ADDENDUM NO. 3

Date February 18, 2025

Kelso School District

Coweeman Middle School Cladding Replacement

R111

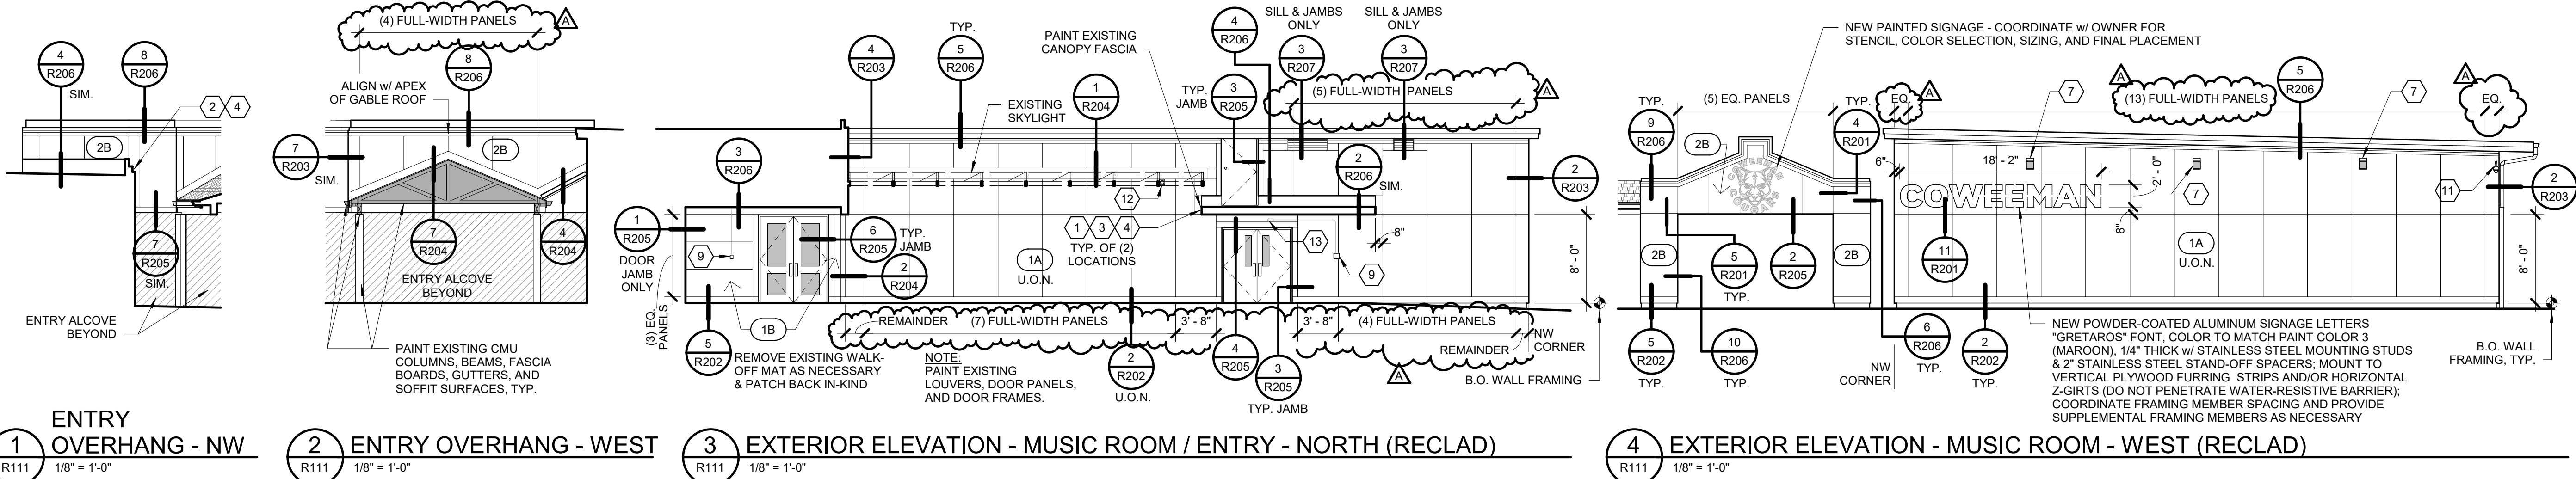
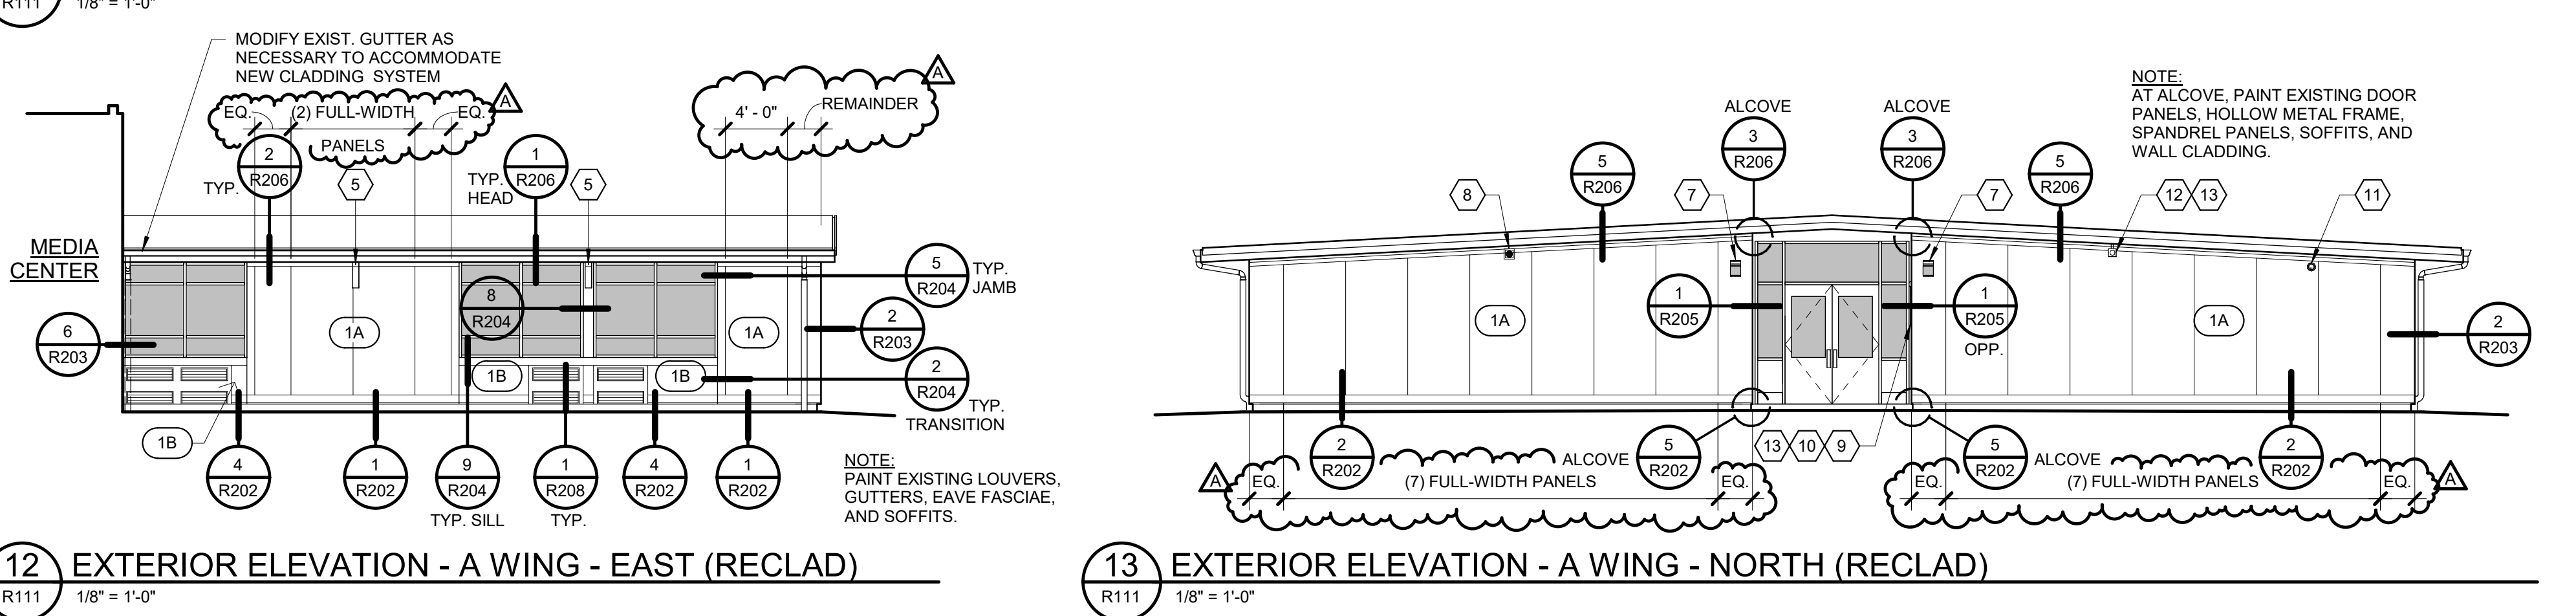
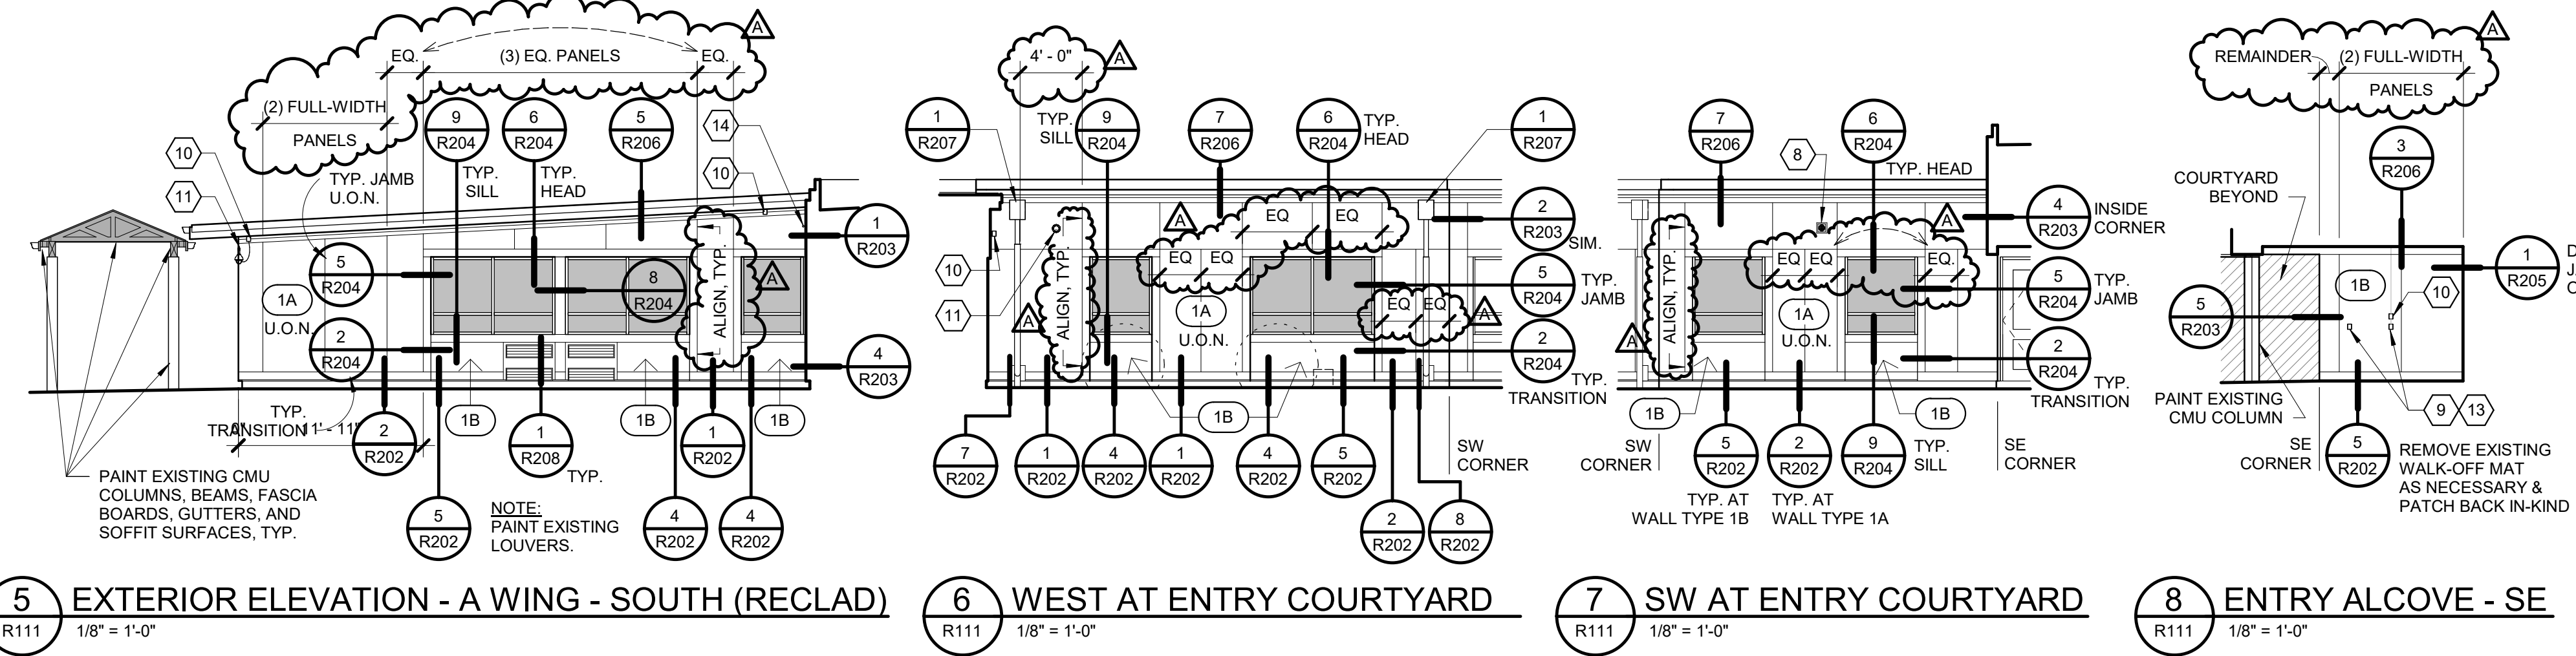
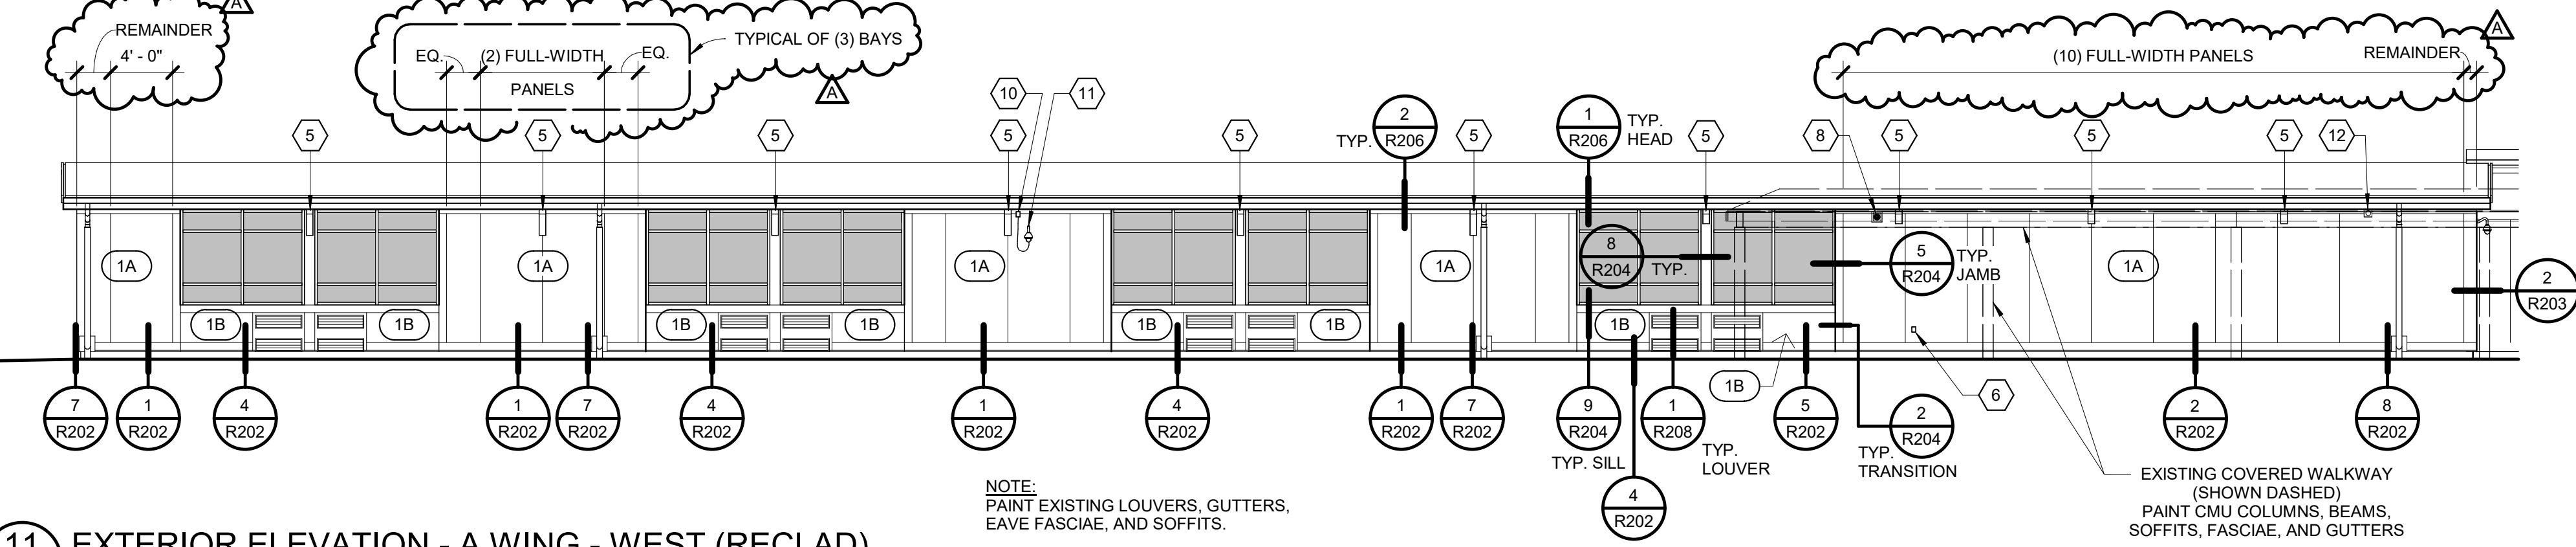
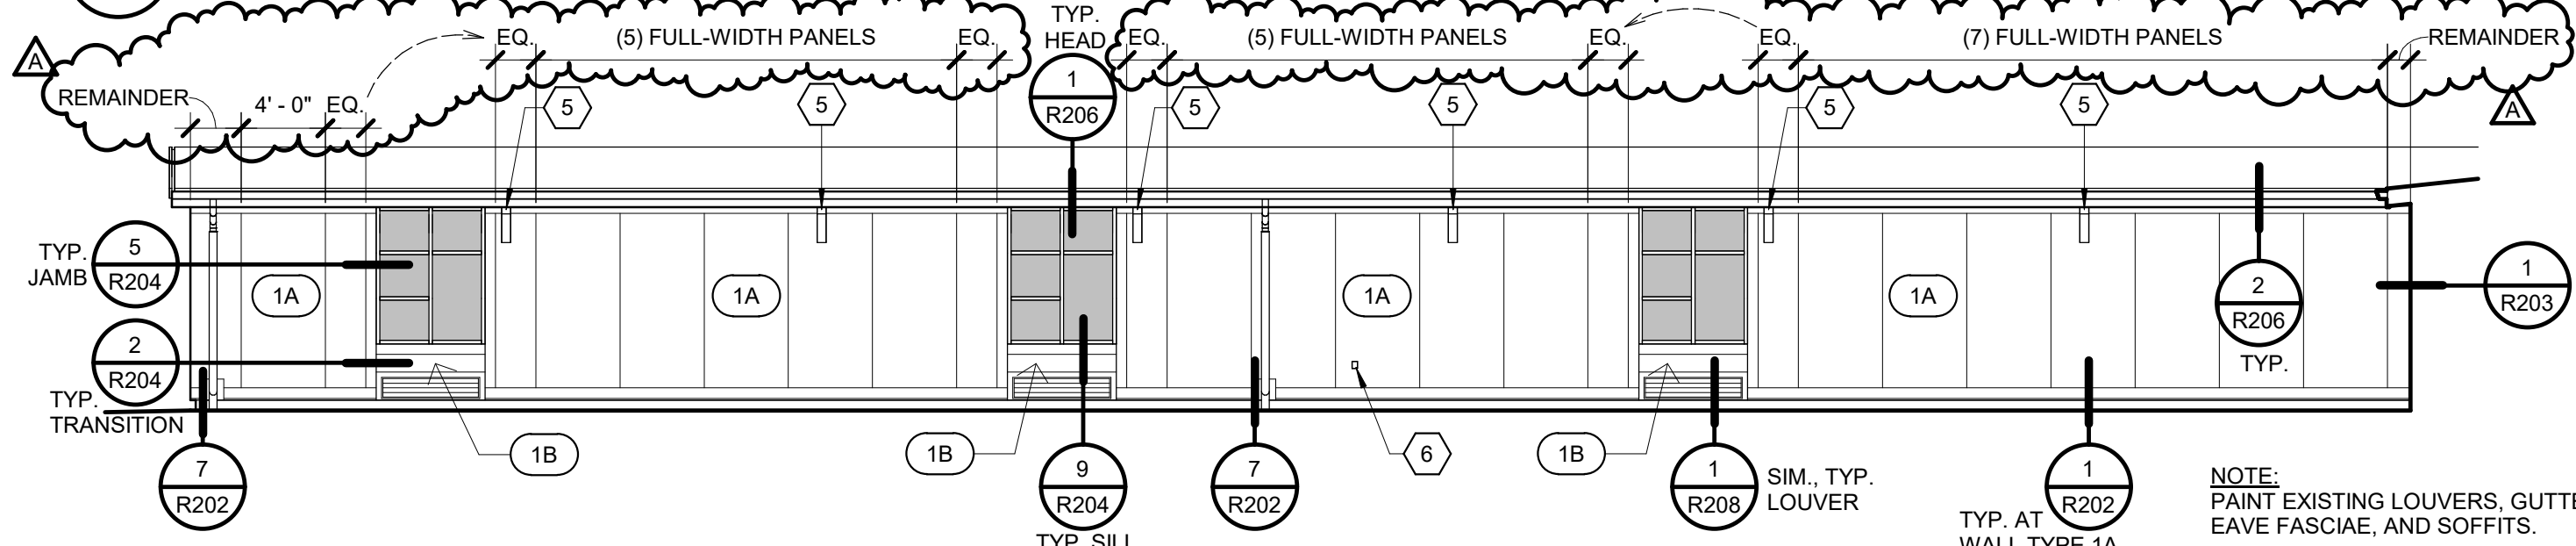
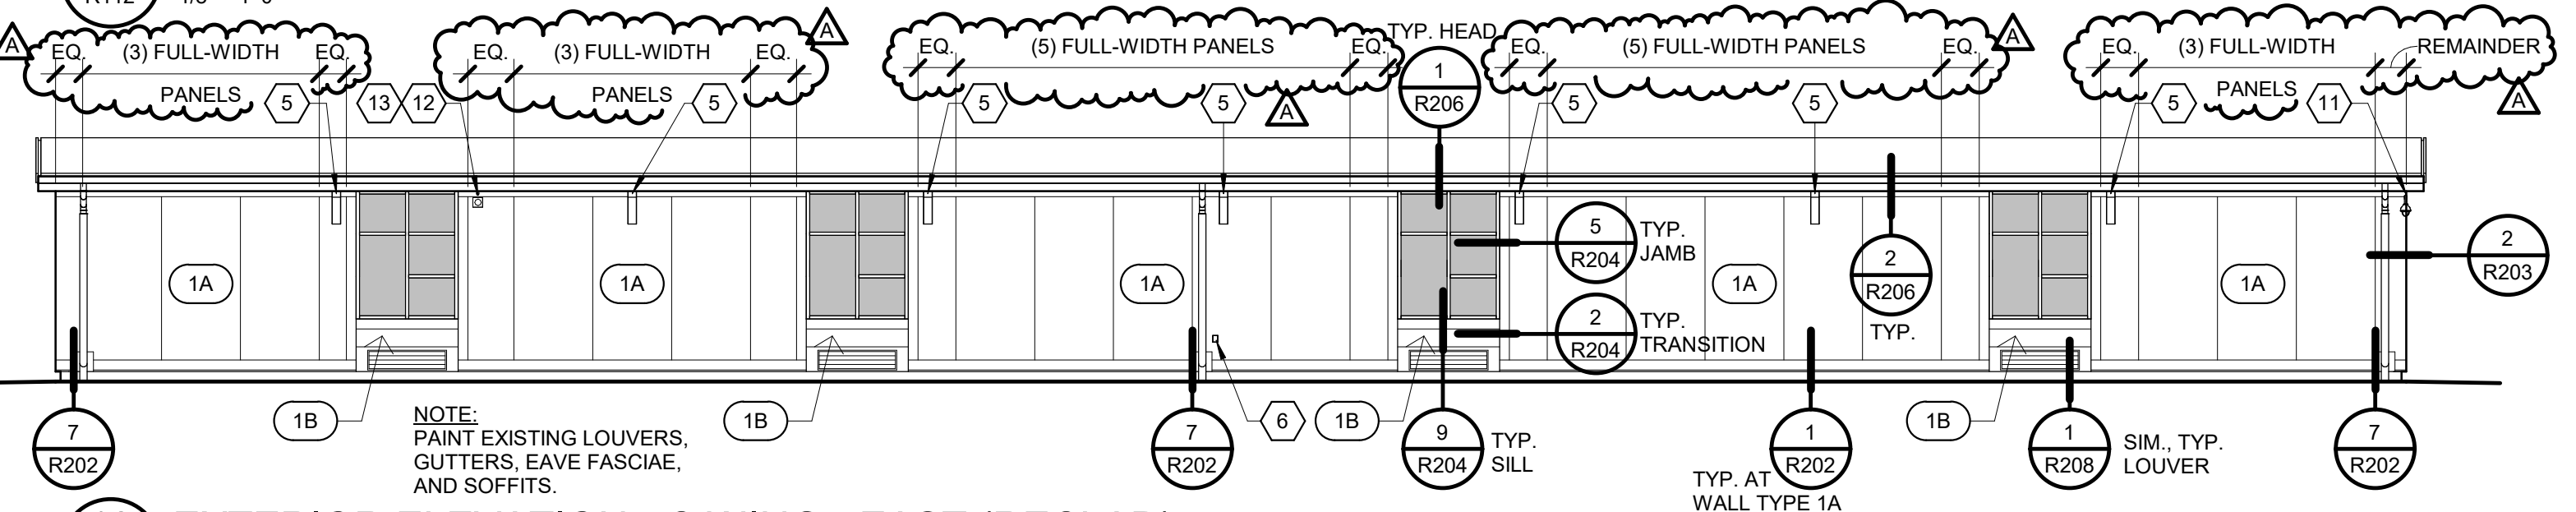
Item	Reference	Description
3.01	<i>Drawing Sheet R111</i>	Replace sheet with attached revised Sheet R111. Note the following changes: <ul style="list-style-type: none">• Altered layout of fiber cement panels to reduce the need for cutting panels to custom widths.• Added Addendum No. 3 revision identifier.
